In The Matter of the Resource Management Act 1991 ("the Act") And
In The Matter Rolleston Plan Change 73 – Holmes Block

OFFICER COMMENTS OF ANDREW BOYD

Figure 2: Pines Resource Recovery Park site using the applicants 600m buffer taken from the boundary of the maturation, screening and load out area.

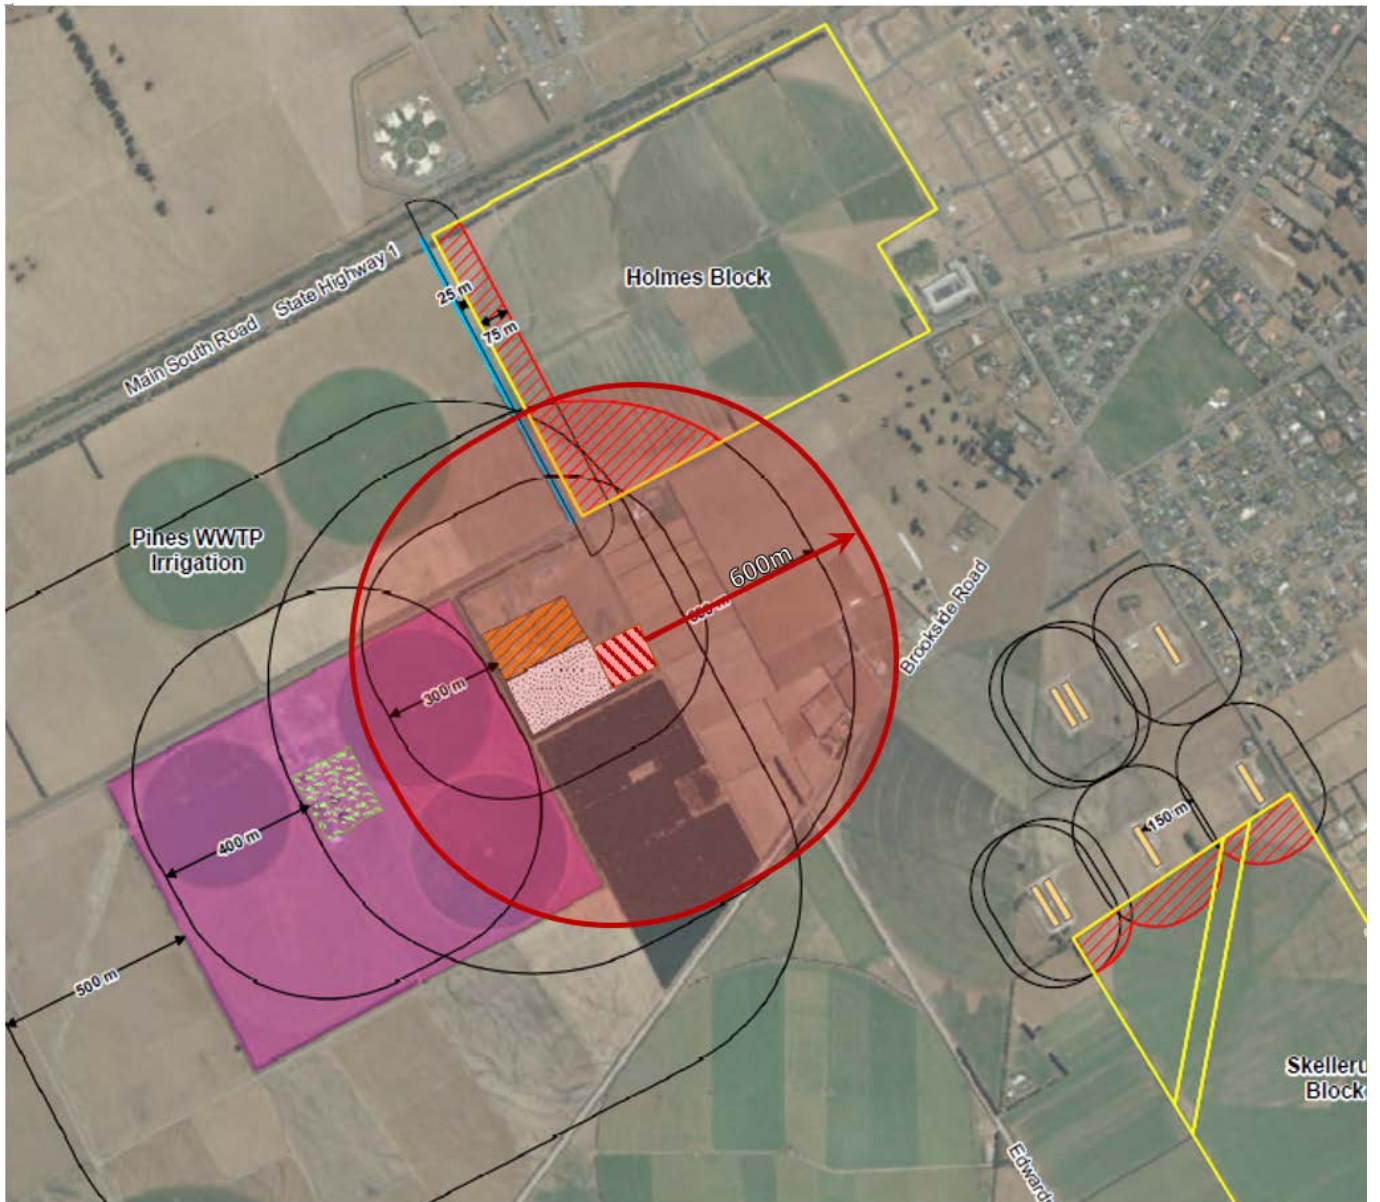
24. I note that the assumed volumes were not clarified with Council prior to submitting the odour assessment. Incoming organics volumes were already at 8,000 tonne per annum at the time PC73 was lodged in November 2020.

25. Council had been seeking clarification from ECan on organic volumes because some risk of ambiguity still existed, as CRC190492 provided no limit on the volume of organic material composted at the Recovery Park. This review led to the variation being treated as a new air discharge consent (CRC211594). Within the new consent, limits were applied to the materials able to be received onsite. For this reason the assessment (Section 1.3.1, Appendix H) of odour effects based on 4200 tonne of organic waste is not accurate.

26. Section 2.2.2 of Appendix H states that *“In summary on the basis that the throughput is maintained close to the current throughput, i.e., limited to 4,200 tonnes/annum and there is a high degree of control in the manufacture of the compost, the leachate management (particularly maintaining both of these in an aerobic state), and given the location of the proposed residential area, a buffer distance of 600 m is considered to be reasonable. This is consistent with the distance to the existing dwelling to the north east of the compost operation”*.¹

27. At the time of lodging PC73, organics tonnes were at 8,000 tonne per annum. Condition 2a of CRC211594 provides for 53,000 tonne per annum. Council expects organic tonnages to increase to 53,000 tonne per annum over the duration of the consent, i.e., through to December 2044.

28. On the basis of the Australian guidelines referenced in Appendix H in the Plan Change application, I consider that the buffer distance should be increased to ensure an appropriate distance is achieved between the Resource Recovery Park and the Plan Change site:

- **South Australian EPA** Minimum Expectations: Existing composting facilities should be protected from encroachment from new developments. In the absence of site-specific risk information an effective buffer is 1,000 m between new developments and composting facilities, measured from the outer boundary of the area licensed to undertake composting.
- **Victoria EPA** recommend separation of 2000m for the tonnages Council forecast²:

29. I note that this recommendation is for “Green Waste” – Garden and Landscaping Organics. The Recovery Park receives Food Organic and Garden Organic (‘FOGO’) waste, increasing the odour potential and therefore arguably the setback distance further than the 2,000m in the table above. The Victorian EPA classifies kerbside FOGO material as ‘#3 Medium to High risk category’.

30. The Golder letter dated 1 February 2021, responding to requests for further information, reads: *“Based on review of aerial photographs it is considered unlikely that the throughput will be able to substantially increase beyond what is currently being undertaken within the footprint defined in the current consent application, i.e., the area defined appears currently to be close to full utilisation. Accordingly, the conclusions reached by Golder in respect of reverse sensitivity effects associated with this activity and its location are considered to be robust”*.³

31. This assumption regarding capacity is factually incorrect. During the issuing of Consent CRC211594, a maximum limit of 53,000 tonnes input per annum was established as appropriate for the composting area. The existing area is partially used for storage of overburden (which may appear as composting activity on aerial photographs). The existing area has been under-utilised (with current volumes) as there is no need to efficiently use the available space. Volumes of mature compost material onsite at any time varies because arrangements to sell compost vary from year to year, and seasonally within years. With more efficient utilisation of the entire available space, the maximum volume of 53,000 tonnes per year could be composted.

32. Golder's assumption that composting operations could be extended Westward is incorrect. Immediately adjacent is the Wastewater Processing Plant. Composting operations are directly adjacent to the border pine plantings – a requirement of the site designation.

46. To safeguard critical Council infrastructure, I would recommend adopting Victoria EPA's separation distances for this new development proposed under PC73, with a minimum setback of 1000m from the compost maturation, screening and load out area.
